Docket Item # 3  
BAR CASE # 2008-0249

BAR Meeting  
January 21, 2009

**ISSUE:** Addition and alterations  
**APPLICANT:** Robert Bentley Adams & Associates  
**LOCATION:** 702 South Fairfax Street  
**ZONE:** RM/Residential

Figure 2. Views of front (west) elevation and side (south) elevation from South Fairfax Street.

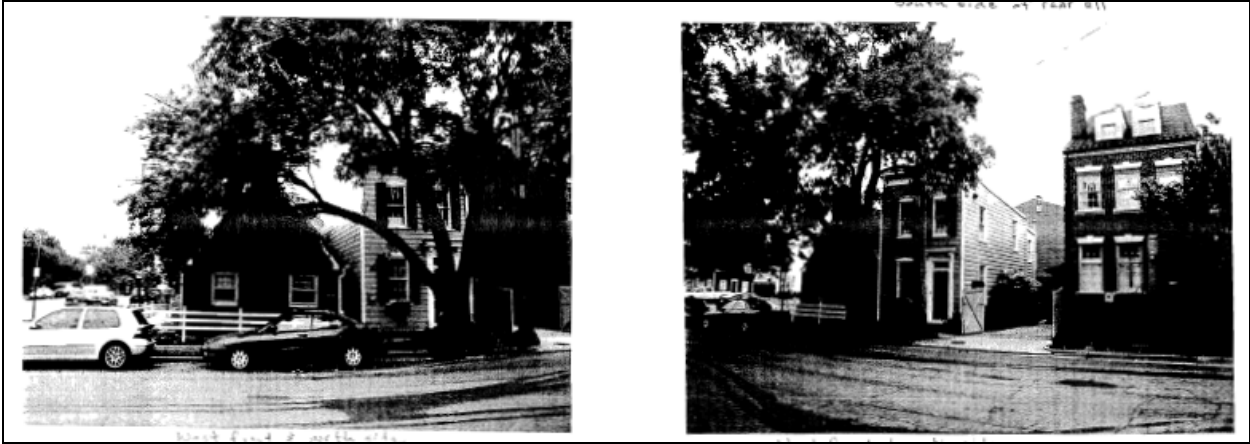
Staff is concerned about the transition between the fiber cement siding on the addition and the wood siding on the historic house on the south elevation, where the addition wall is flush with the existing rear ell. Of concern is how to successfully transition from wood siding to fiber cement siding on an uninterrupted wall plane. In order to clearly differentiate the old from the new, as well as the change of materials, it is recommended that a vertical wood trim board be installed on the south elevation.

3. The applicant shall install a vertical wood trim board on the south elevation to differentiate the historic house from the addition and provide a clear break between the wood and fiber cement siding.
